Ref: EPG/2022/TFW/CSS/Q002/01

### **Coelbren Health Centre, SA10 9PE, Mine and Landfill Gas Risk Assessment**

**Extract from 1919 map**

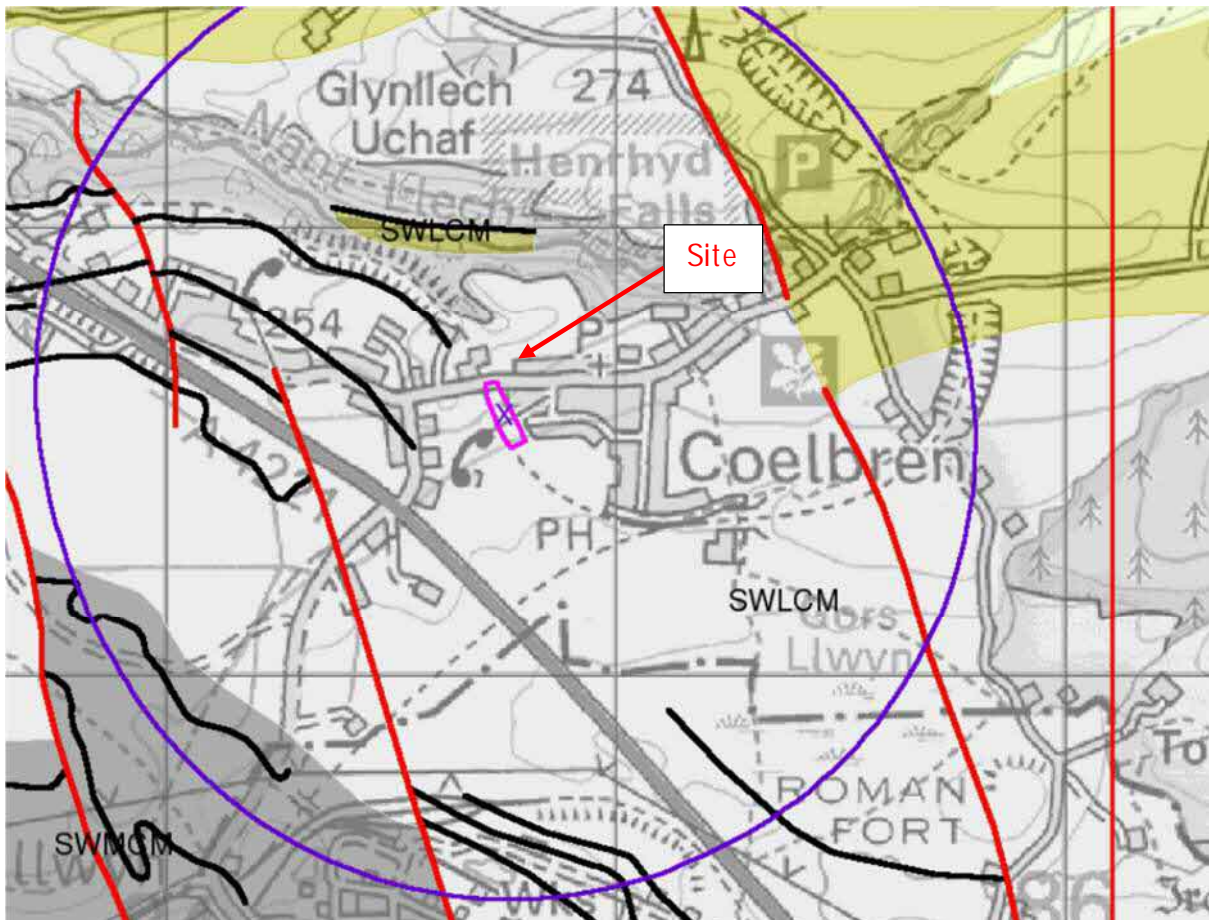
- There are no mine entries within 50m of the site boundary. The nearest entry will be the Ffoddu Colliery drifts and air shafts are shown on the 1919 Edition map which are located 105 m or more to the south of the site. This is down dip of the site and

therefore will not influence the site. The colliery is in the same area as a series of coal seams that terminate west of the site. The map (extract below) shows the drift enters the ground heading south west and there an air shaft further south. Thus it does not pose a risk of mine gas migration towards the site.

**1919 map overlain by current Google Earth image**

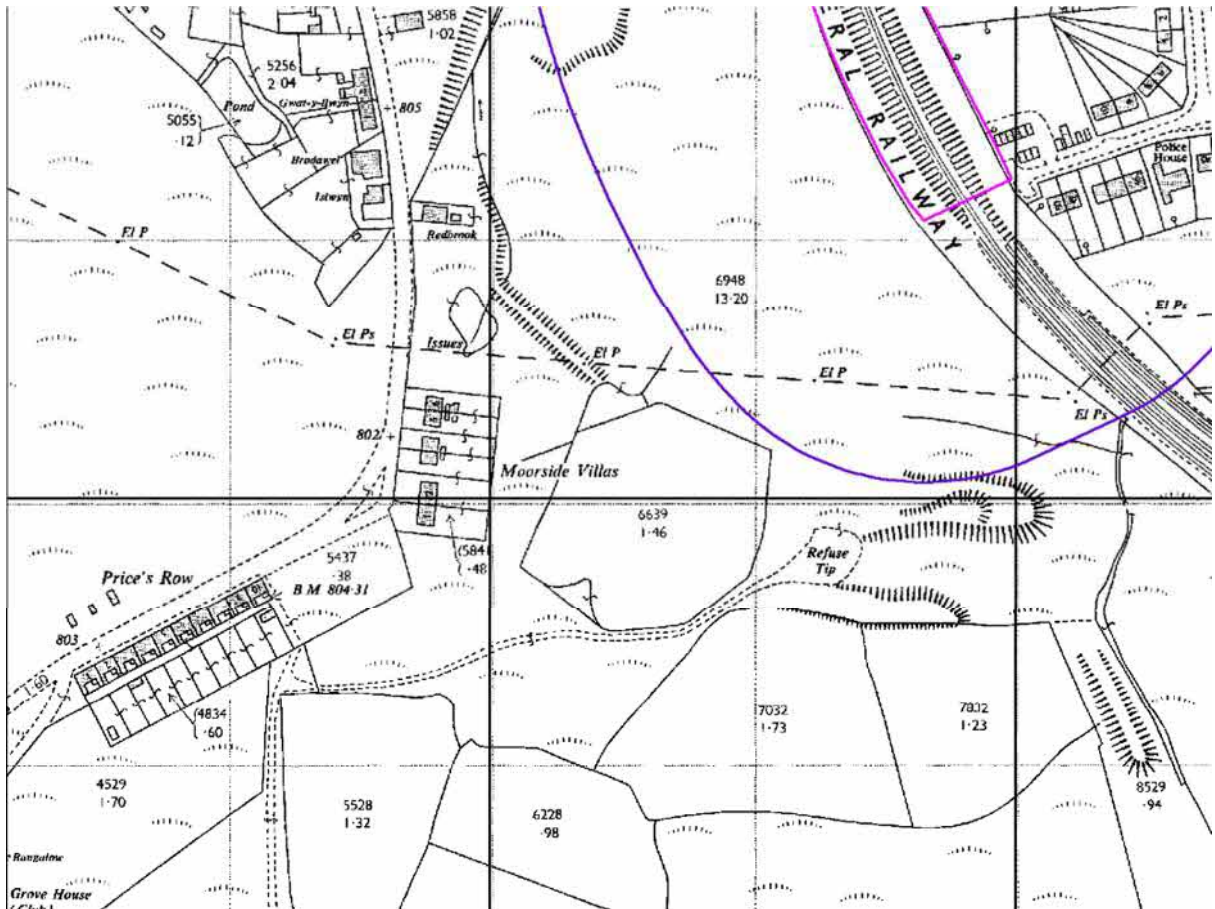
- Inspection of the old maps shows this is an old ironstone quarrying area which was extensive across the area on the 1888 map. The area of the refuse tip is shown as an old shallow quarry on the 1888 map. The 1919 map shows it is level with the surrounding area and the quarry excavations are no longer shown. Ffonddu Colliery is now present. The evidence shows that prior to deposition of waste the area of the tip was leveled with colliery spoil to

surrounding ground levels. An extract of the 1919 map overlain by the current Google Earth image is shown below.

**Extract from 1962 map**

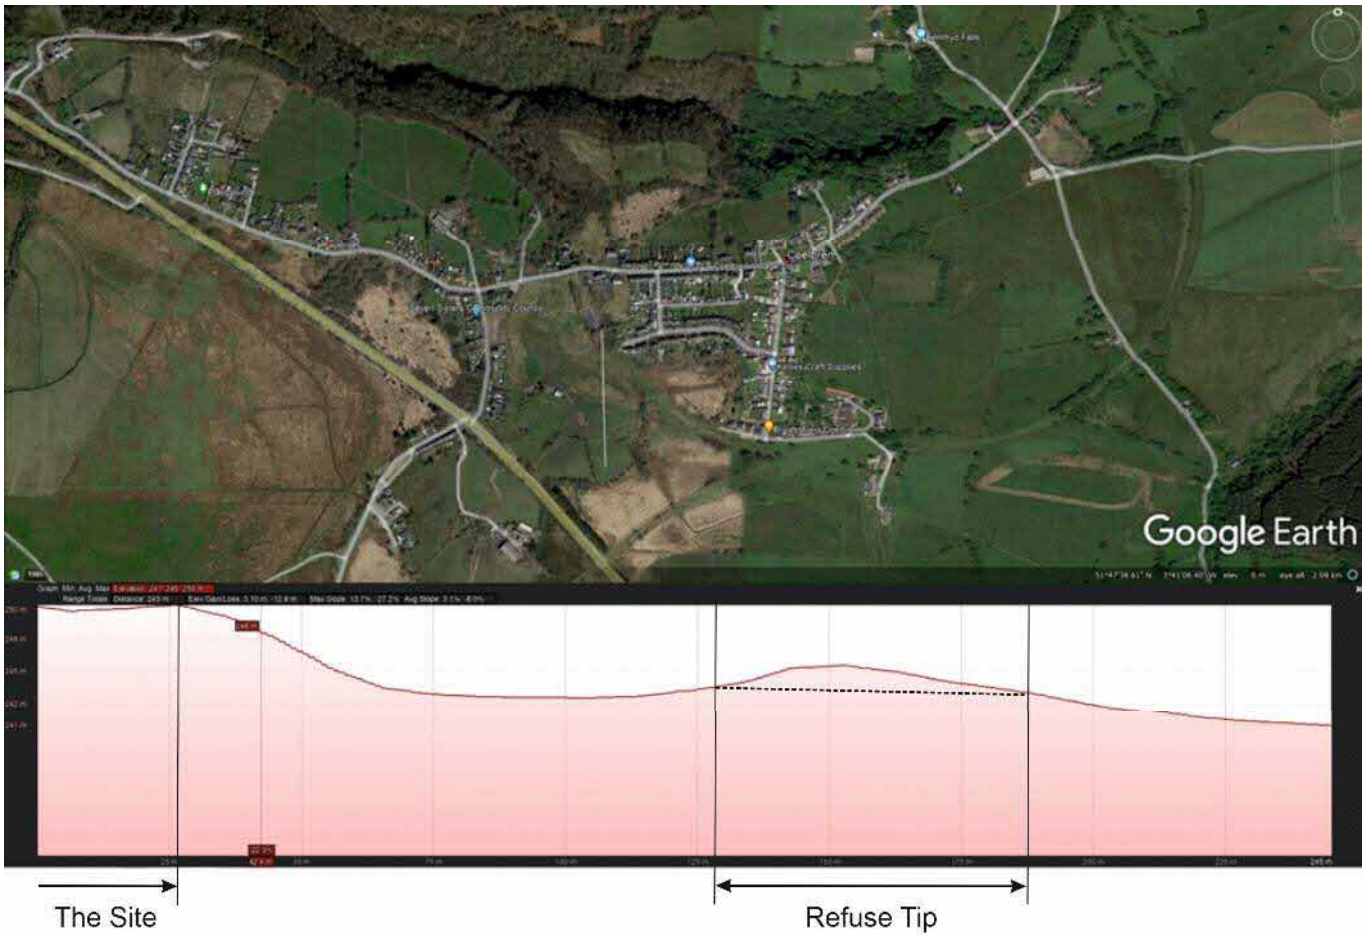
- The refuse tip is first shown on the 1962 map (extract below). At such time there would be limited degradable material in any domestic refuse and it would mainly be ash, glass, etc. The tip is last shown on the 1993 map although it appears that filling was complete by the 1987 map. Later waste may have a higher degradable content.

Lidar map

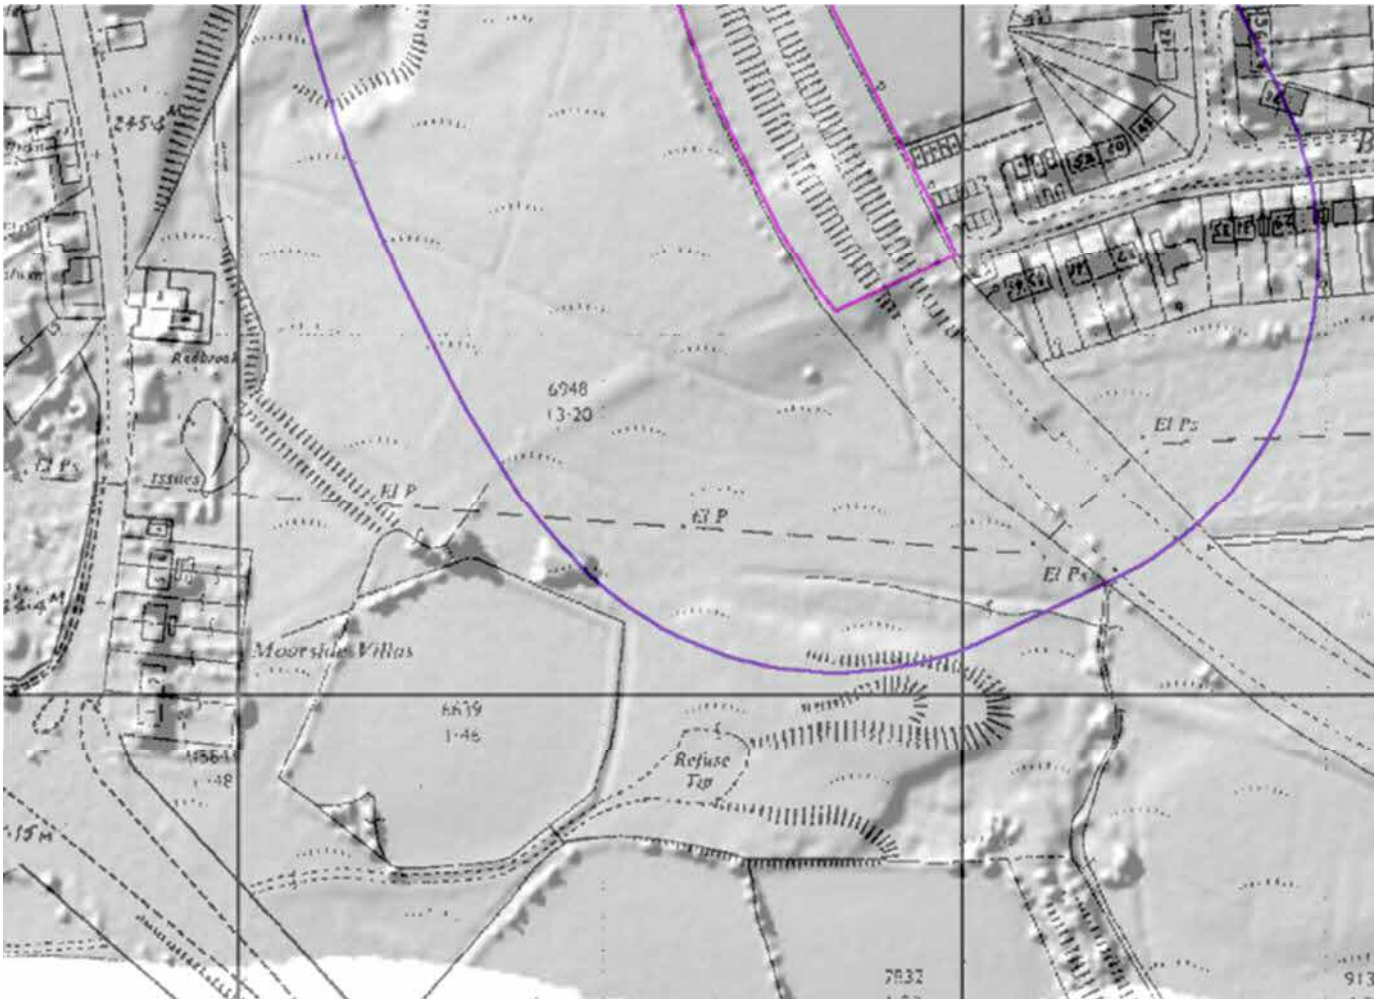
- The LIDAR map of the site provided below confirms that the landfill is a land raise (and it corresponds to the position shown on the maps as demonstrated by the overlay). It also shows that the former cutting below the site has not been completely filled and the site is lower than the surrounding ground.

**Historical map overlain onto Lidar map**

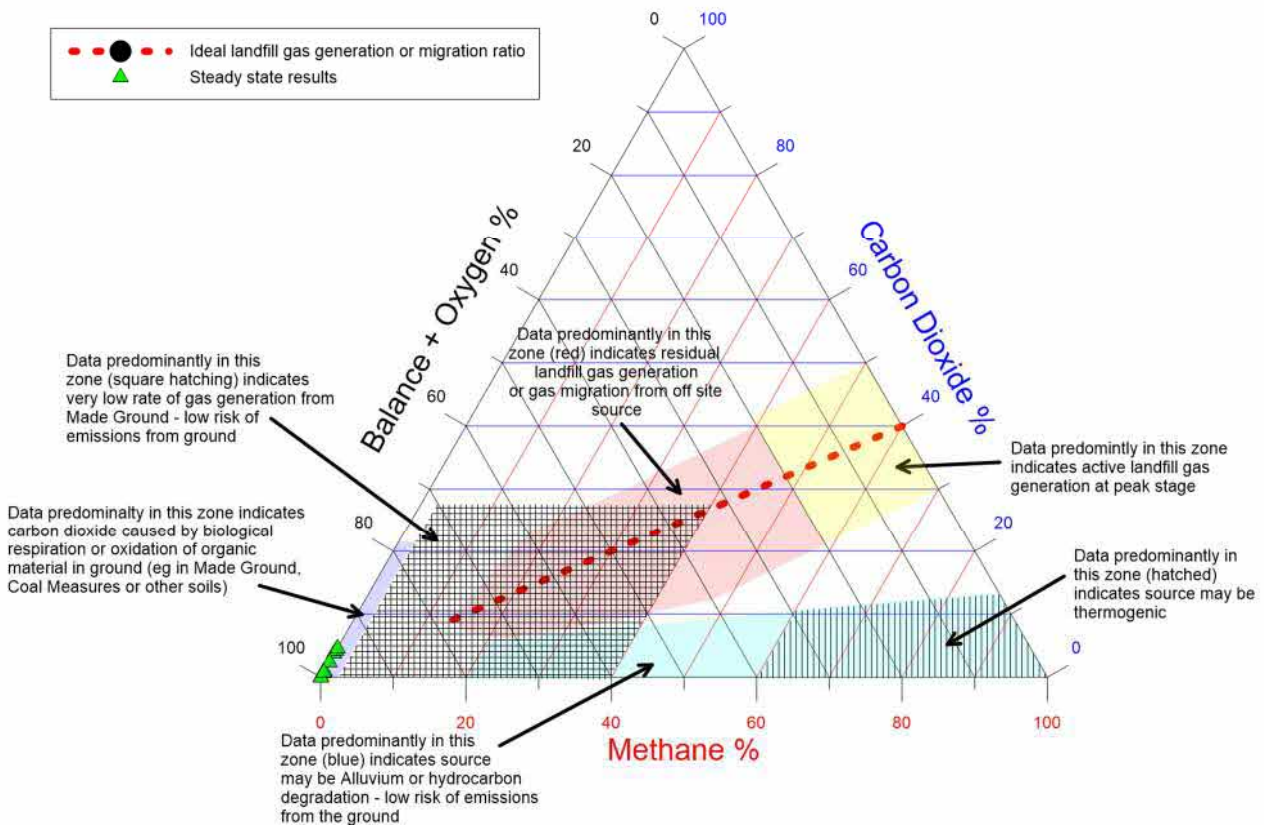
Therefore even if the landfill was filled with domestic refuse, because it is above ground it would not cause landfill gas migration to this site. Furthermore the Glacial Till would also limit the potential for gas migration over 241m because of its low permeability.

**Ternary Plot Steady State Data**

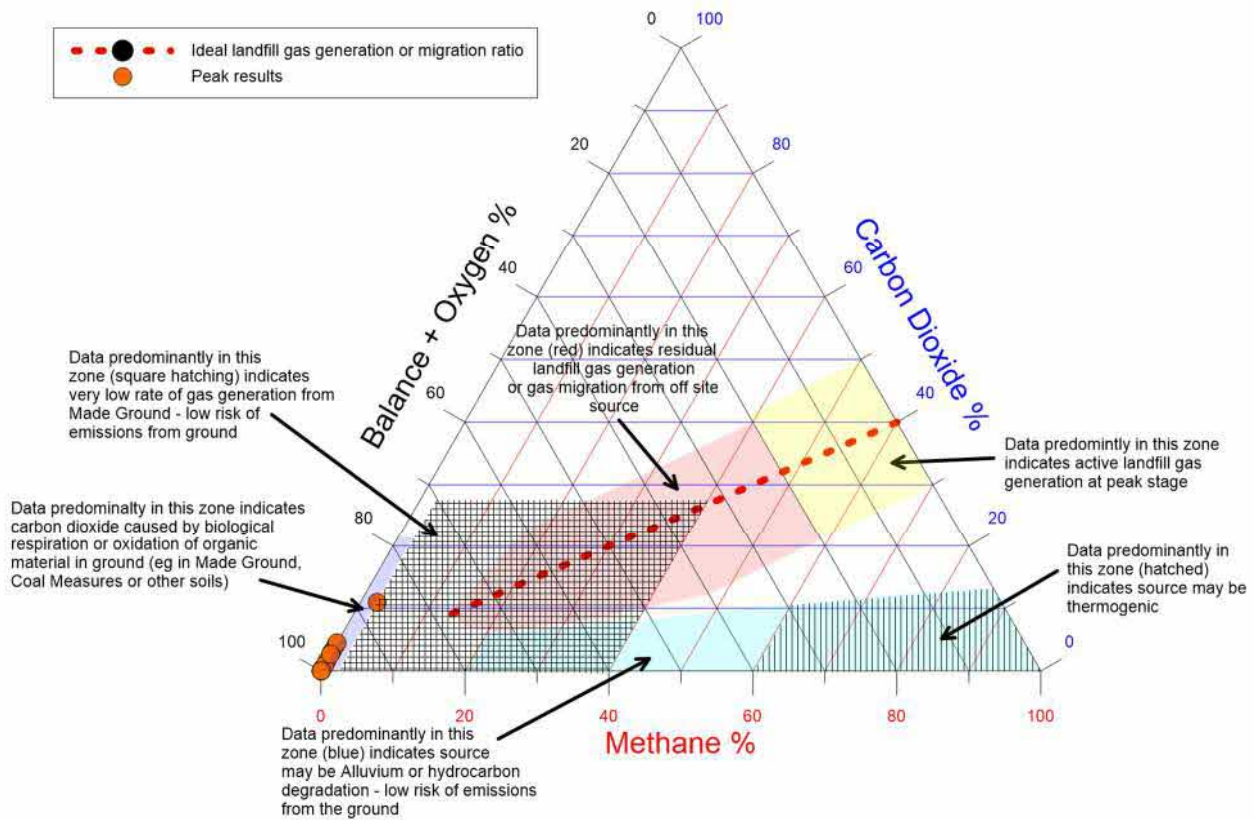
BS8485 and BS8756 indicate that steady state values of gas monitoring data should be used in a risk assessment. In particular peak flow rates on opening a gas tap are not representative of the surrounding gas regime. Steady state results show methane <0.1%, carbon dioxide up to 4.6% and flow rates up to 0.4l/h. The slightly elevated carbon dioxide concentrations are caused by biological respiration of organic material in the Glacial Till as shown in the Ternary plot in the Figure below. All the hazardous gas flow rates are less than 0.7l/h and the site is characterized as Characteristic Situation CS1 in accordance with BS8485: 2015 + A1: 2019.
